Project/File: 35849 - Hereford Urban Village

**Reference: Civil and Flood Design Response to Environment Agency Comments for Application  
Ref: 251273/CD3**

**PROPOSED FLOOD ALLEVIATION SCHEME TO ADDRESS HISTORIC FLOODING ACROSS THE MERTON MEADOWS AREA OF THE CITY. CAR PARK (PLOT 1A & 1B) TOGETHER WITH PLOTS 4 & 5 EAST OF WIDEMARSH STREET HEREFORD HEREFORDSHIRE HR4 9JU**

Figure 4- Proposed water connection to maintain flows into the existing canal

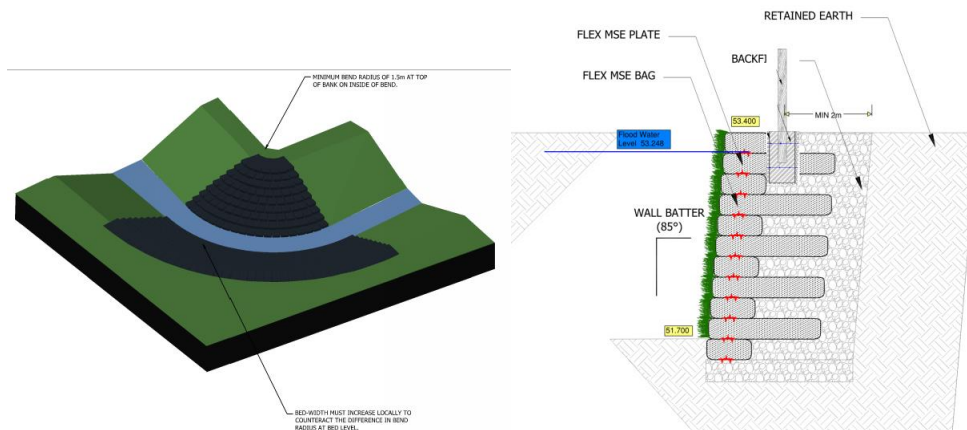
It is also best practice is to retain as much as possible of the previous channel as a backwater habitat. In Plot 5 all the current alignment is shown as being infilled. Implications for the existing bankside trees are also not clear.

FUTURE CONNECTION TO MAINTAIN FLOWS INTO THE EXISTING CHANNEL, WHICH WOULD CONNECT THE NORTHERN WETLAND/STORAGE AREA TO THE CHANNEL ALONG THE EASTERN BOUNDARY AND PROVIDE FLOW OF WATER TO THE EXISTING TREES.

DETAILS TO BE AGREED AT NEXT STAGE OF THE DESIGN.

180m LONG AND UP TO 1.2m HIGH RETAINING WALL WITH PERMANENT HANDRAILS BY GRAVITAS - FLEX MSE DRAWING NUMBER F002 B. HANDRAIL TO BE DESIGNED FOR HORIZONTAL LINE LOADING OF 1.5kN/m.

IF THE TREE ROOT PROTECTION ZONE ARE FOUND TO BE LESS THAN ANTICIPATED, THE GROUND CAN BE REPROFED TO A 1:3 GRADIENT AND THE RETAINING WALL OMITTED.

### **B.1 35849-HYD-1-XX-M3-C-90110 Flood Compensation Plan**

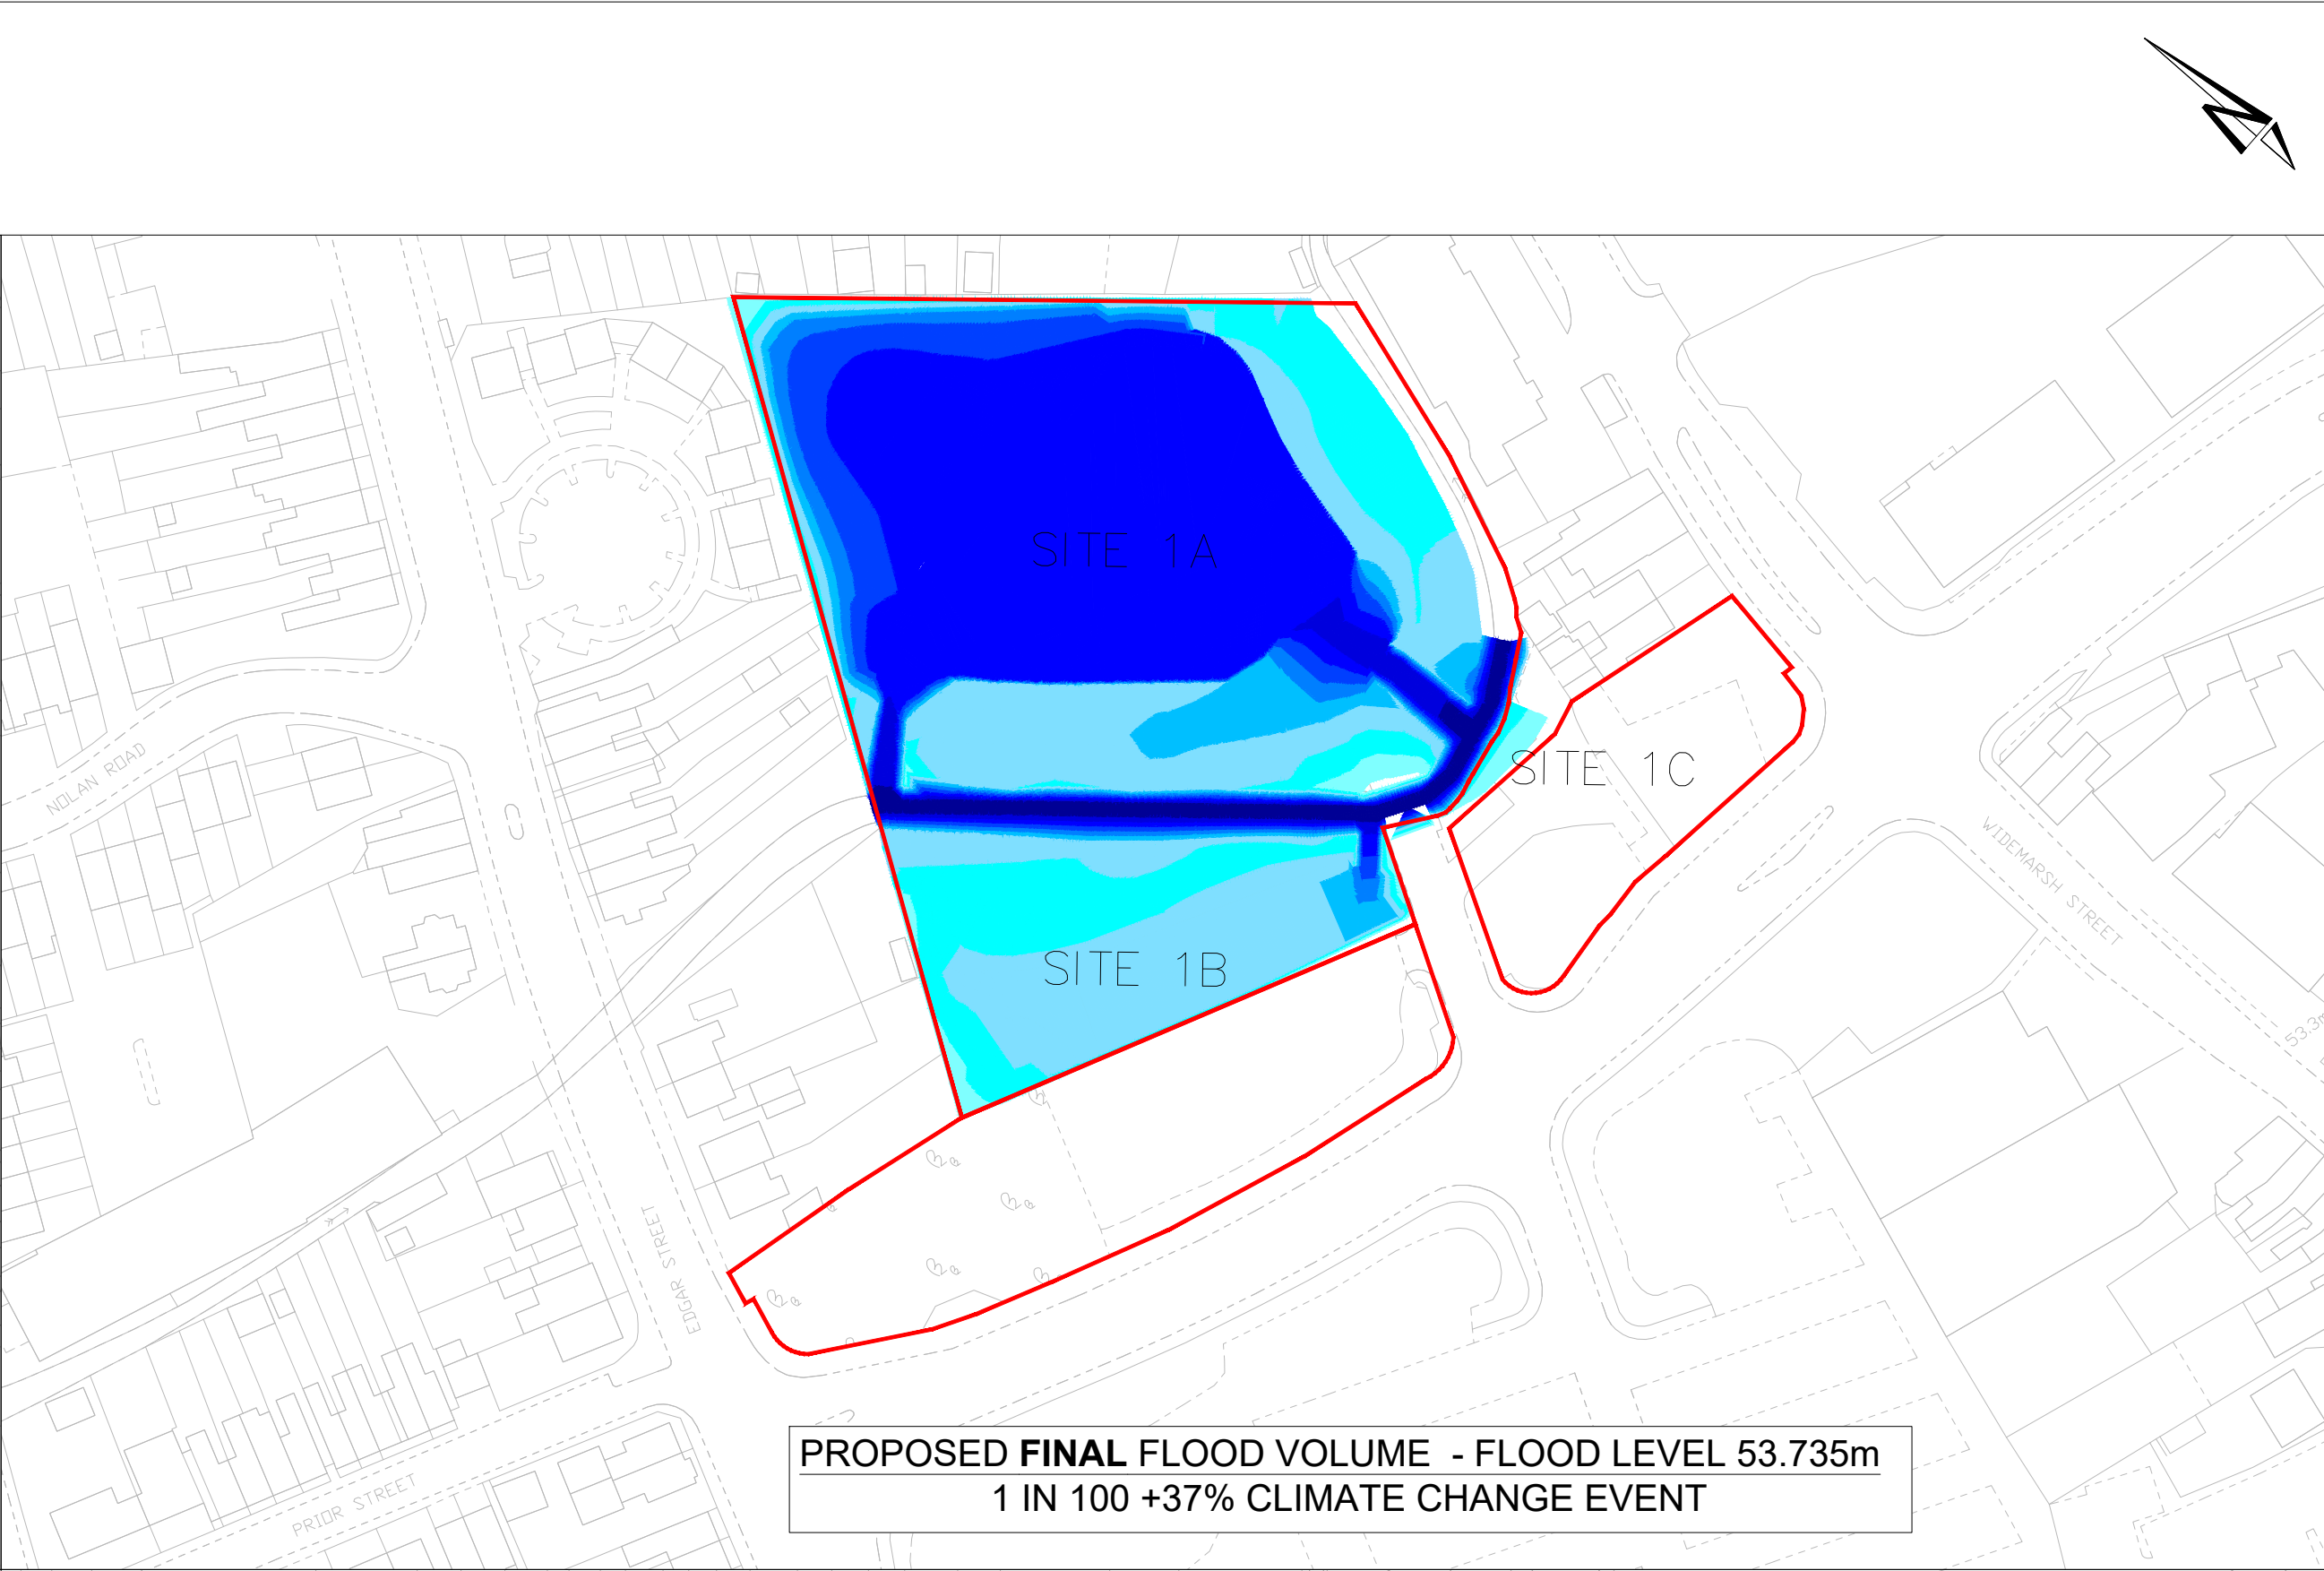
- “What additional flood storage capacity did the Merton Meadow FAS, in the 4 plots, actually provide?”

### *Plot 1 - Drawing 35849-HYD-1-XX-M3-C-90110\_P05 Flood Compensation Plan*

The current flood storage required is 9,861 m<sup>3</sup> over an area of 10,100 m<sup>2</sup>. The average depth of water is 976mm.

The proposed storage volume is 11,316 m<sup>3</sup>, covering the same area, which corresponds to an average water depth of 1,120 mm.

From the above, we can see that the additional capacity within plot 1 is 1,455m<sup>3</sup> (11,316-9,861m<sup>3</sup>) or, on average, there will be a reduction in average water depth of 144mm (1,120mm-976mm).

### **C.1 Figure showing the difference in the extent of the flood between the existing baseline model and the post-development model**

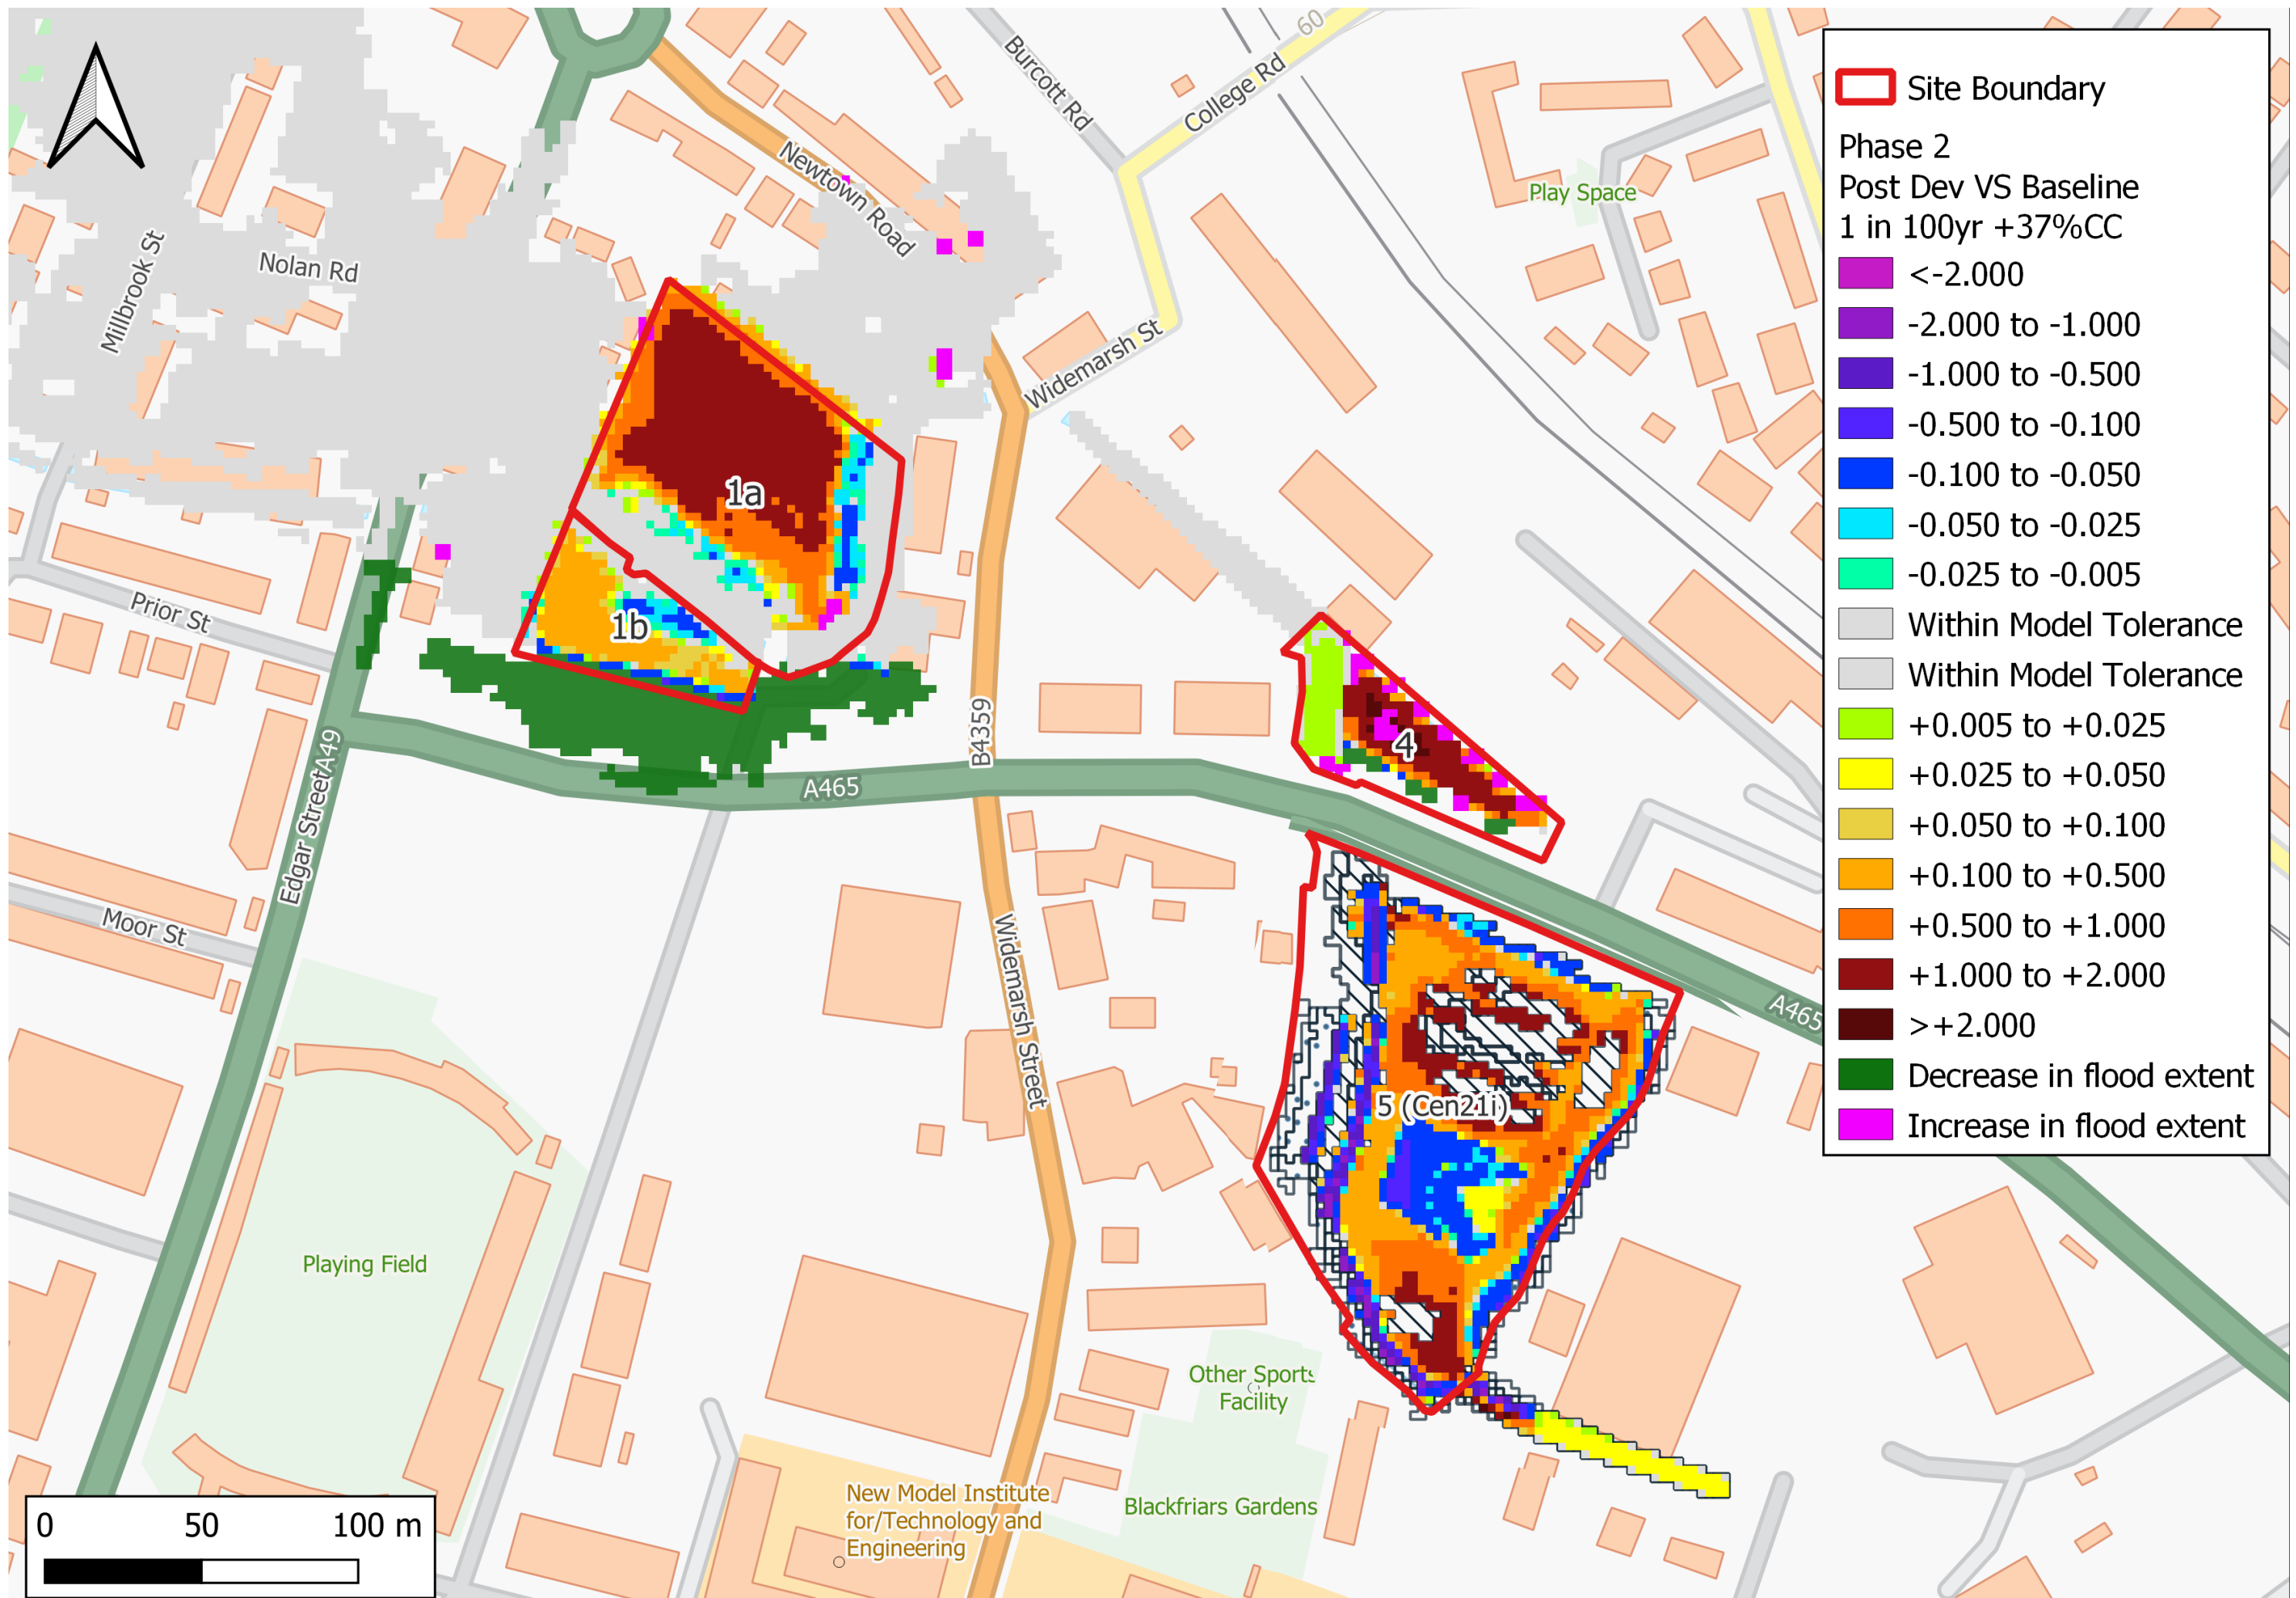
- “Whether post-development outlines with the new additional storage proposals in place had been produced in order to demonstrate the betterment being provided by the scheme.”

In line with the requirements of national and local planning policy, a detailed assessment of flood risk to the Merton Meadows site is being carried out. This includes a reappraisal of existing modelling studies that have been carried out historically, as well as further detailed modelling to consolidate and update the various studies, thereby presenting a comprehensive picture of flooding at the site from the key watercourses in the area. The proposed methodology involves reappraising the baseline conditions at the site, with the results then informing the design of flood alleviation options to mitigate risks at the site. The proposed flood alleviation scheme was then incorporated into a post-development model, which we compared with the baseline scenario to assess the potential impacts of the development.

The results of the baseline modelling indicate that sites 1a, 1b, 1c, 2b, 4 and 5 are likely to flood in the future fluvial 1 in 100-year event. Site 2a is shown to remain free from flooding. Using these results, options have been developed to mitigate flood risk to the site, including the re-profiling of sites 1a and 1b to enhance floodplain storage and creating a wetland habitat within site 1a to capture and store water away from the proposed development. Within site 5, the Brook will be realigned to a more natural path, with ground levels reprofiled to create a wetland and provide additional floodplain storage. Further storage capacity is also being provided within site 4.

In addition to the above and part of this wider outline masterplan application, it has been proposed that plots 1C, 2A and 2B are filled and the finished ground levels are set 150mm above 1:100years+CC event and the FFL are set further 150mm above the finished ground level or 300mm above the flood level.

The comparison models attached in Appendix C demonstrate that the proposed mitigation measures reduce flood risk to the proposed development without increasing flood risk to adjacent or third-party lands.
